Application for Licence Amendment

Choose an item.	L7851/2002/6
Choose an item.	BHP Iron Ore Pty Ltd
ACN	008 700 981
File Number	APP-0033773
Premises	Mining Area C / Southern Flank Legal description – Mining Tenement ML281SA, ML249SA and Exploration Lease E47/1540-I NEWMAN WA 6753 As defined by the coordinates in Schedule 1 of the Revised Licence
Date of Report	01/05/2026 (FINAL)
Decision	Revised licence granted

Licence L7851/2002/6 is held by BHP Iron Ore Pty Ltd (Licence Holder) for the Mining Area C / Southern Flank (the Premises), located on Mining Tenements ML281SA, ML249SA and Exploration Lease E47/1540-I in the Shire of East Pilbara.

Figure 1: Site general arrangement of Licensed WWTPs, WTPs and Landfills

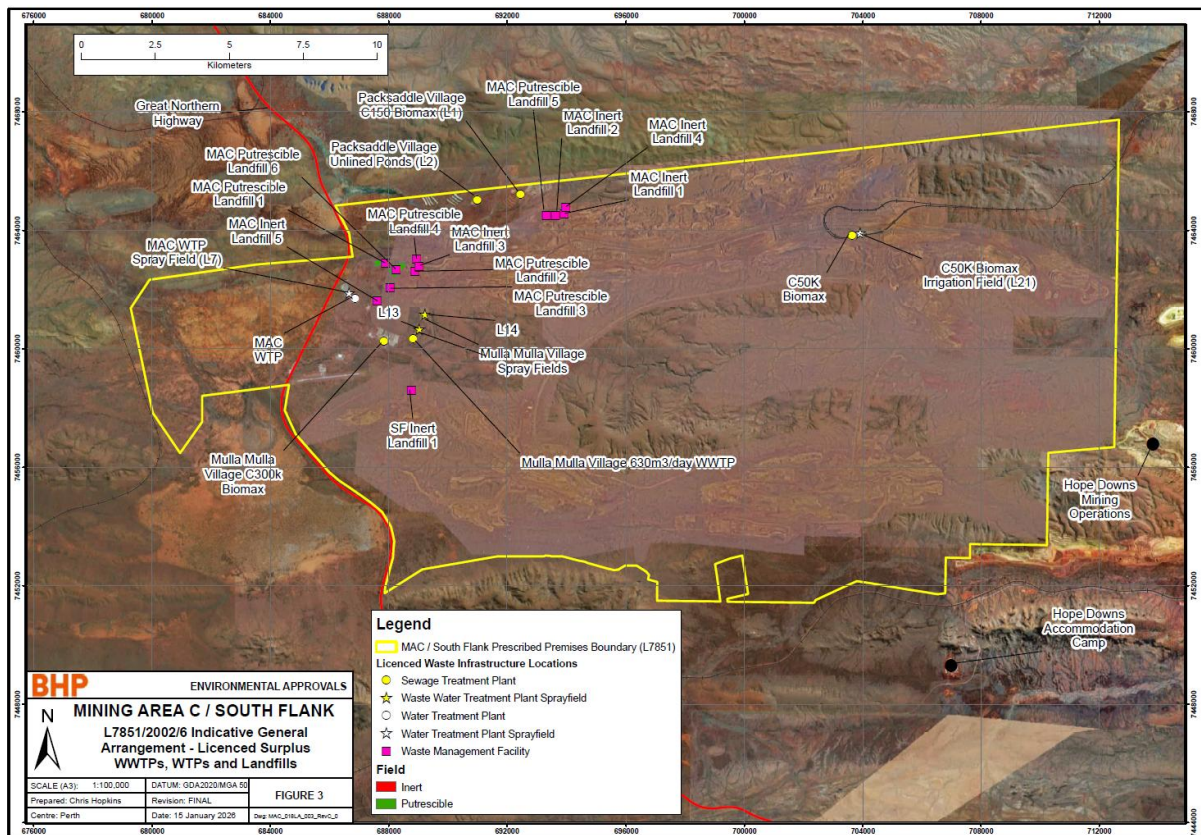
Inert landfill activities occur within the approved prescribed premises boundary. The amendment relates to MAC Inert Landfills 1, 2, 3, 4 and 5, as shown on the licensed arrangement maps. The proposal confirms the reclassification of remaining available space within the central Packsaddle landfill footprint for inert waste use (previously used for putrescible waste disposal). Referred to as 'MAC Inert Landfill 2' and includes two additional inert landfill locations, 'MAC Inert Landfill 4' (immediately north of the existing MAC Inert Landfill 1) and 'MAC Inert Landfill 5' (700m north of the Mulla Mulla Village):

- MAC Inert Landfill 4 will have an overall footprint of 350 m by 250 m. Depth to groundwater is more than 30 m in this area.
- MAC Inert Landfill 5 will have an overall footprint of 300 m by 300 m. Depth to groundwater is more than 35 m in this area.

Refer to Figure 1 below for an outline of the proposed new landfill areas.

The amendment proposes the inclusion of two additional putrescible landfill locations, 'MAC Putrescible Landfill 3' and 'MAC Putrescible Landfill 6', within the approved premises boundary. These sites are located approximately 950 metres southwest and 650 metres west of MAC Putrescible Landfill 2, respectively. The approved annual putrescible waste disposal limit remains unchanged at 5,000 tonnes per year. A summary of landfills is listed below:

- MAC Putrescible Landfill 3 will have an overall footprint of 700 m x 200 m. Trench maximum design within the footprint: length of 450m, width 25m and depth 2.5m deep. Depth to groundwater is ~29m in this area.
- MAC Putrescible Landfill 6 will have an overall footprint of 600 m x 250 m. Trench maximum design within the footprint: length of 600m, width 25m and depth 2.5m deep. Depth to groundwater is ~29m in this area.

Refer to Figure 1 above for an outline of the proposed new landfill areas.
